## AGENDA

February 19, 2013

2. **Crown Castle/Crown Atlantic Company LLC – McGettigan Rd – Map 10, Lot 1-1;** Public hearing for a site plan to replace the existing 185ft self-support tower and construct, in-kind, a new 185ft self-support tower. *(New application)*
3. **Tom Richards dba Fred Richards Auto Sales/Barbara Livoli aka Berkeley Trust Realty – 212 South St – Map 30, Lot 131.** Public hearing for a site plan amendment for a change of use from retail to motor vehicle sales with retail/display spaces. *(New application)*

## Planning Board Meeting

SHEET NUMBER  
 GN-1

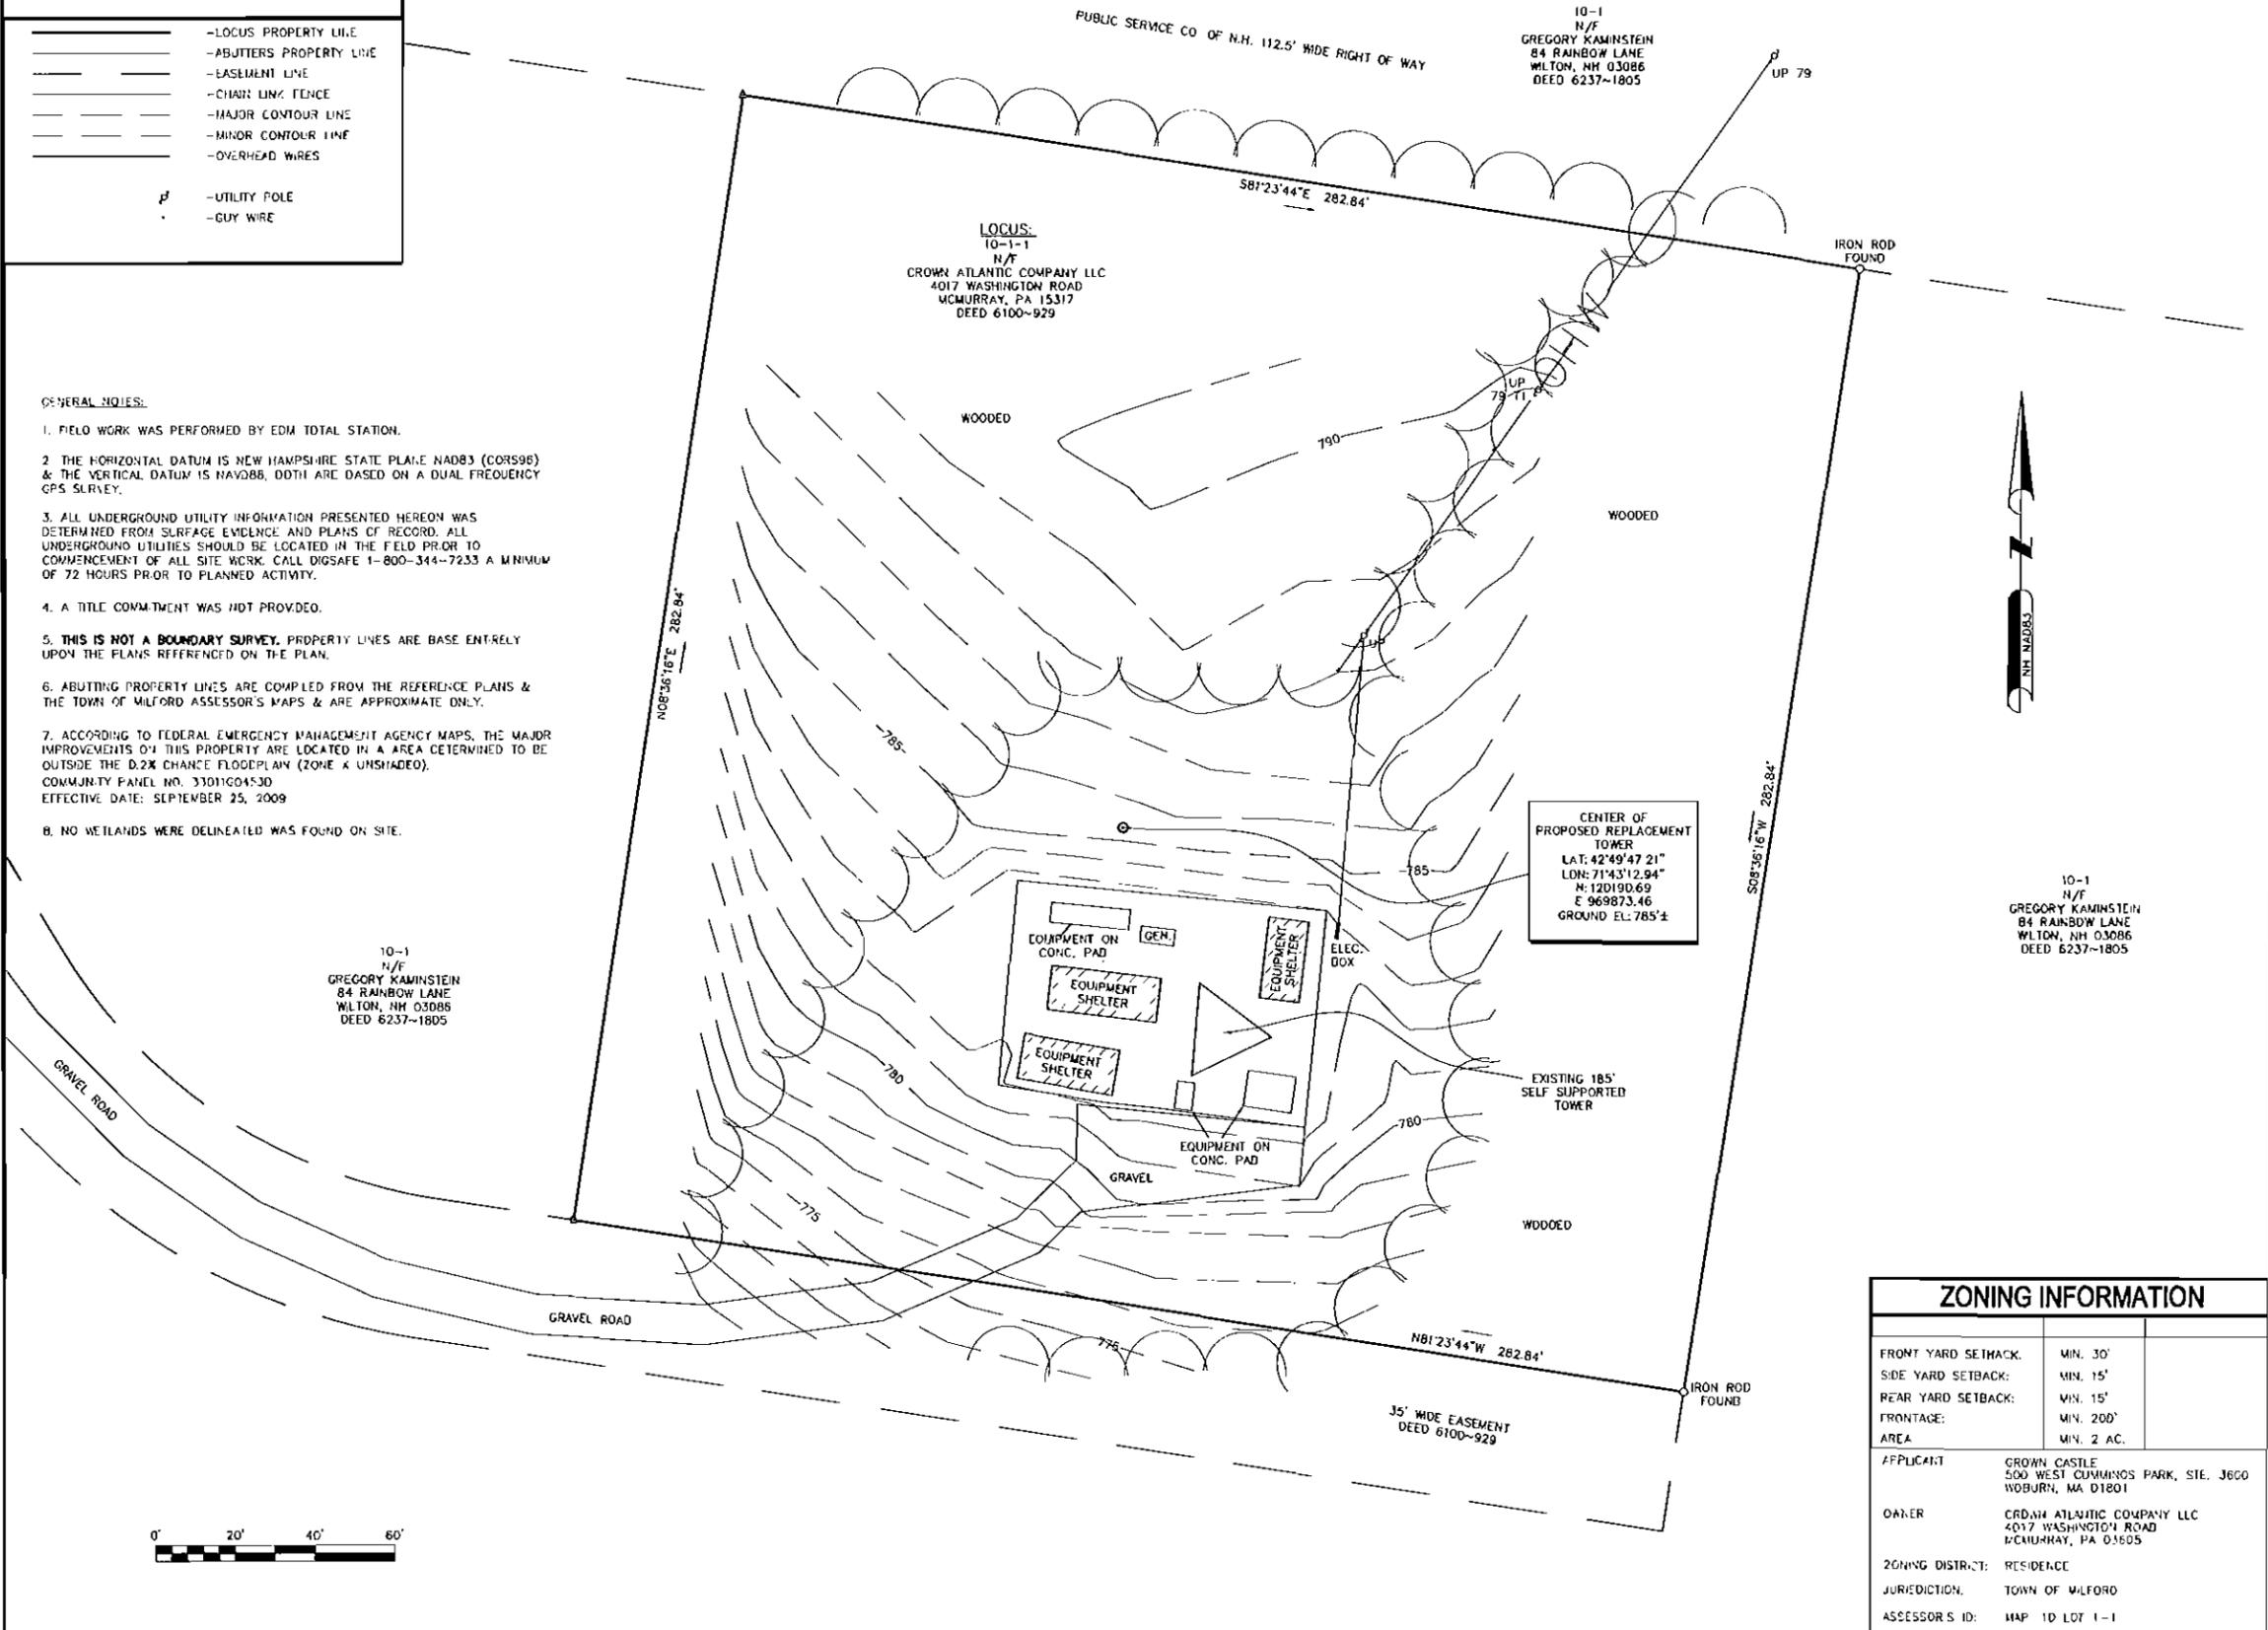
1. Page 1 note 3 should state "Electrical Code: 2011 National Electrical Code" (not 2005)
2. Page 2 Concrete – 1.05.A, a note should be added that states results of the 3 day and 28 day tests shall be forwarded to the Milford Building Department

1. Note 3 on Page 1 should state "Electrical Code: 2011 National Electrical Code" (not 2005)
2. Page 2 a note should be added that states results of the 3 day and 28 day tests shall be forwarded to the Milford Building Department.
3. A note should be added to the plan stating the proposed project may be subject to police impact fees.
4. The original bond will need to be returned to Crown Castle and a new bond request will need to be submitted for the new tower. The amount of security shall be based upon the removal cost, plus fifteen percent (15%), be provided by the property owner, and the amounts certified by a professional structural engineer licensed in New Hampshire.
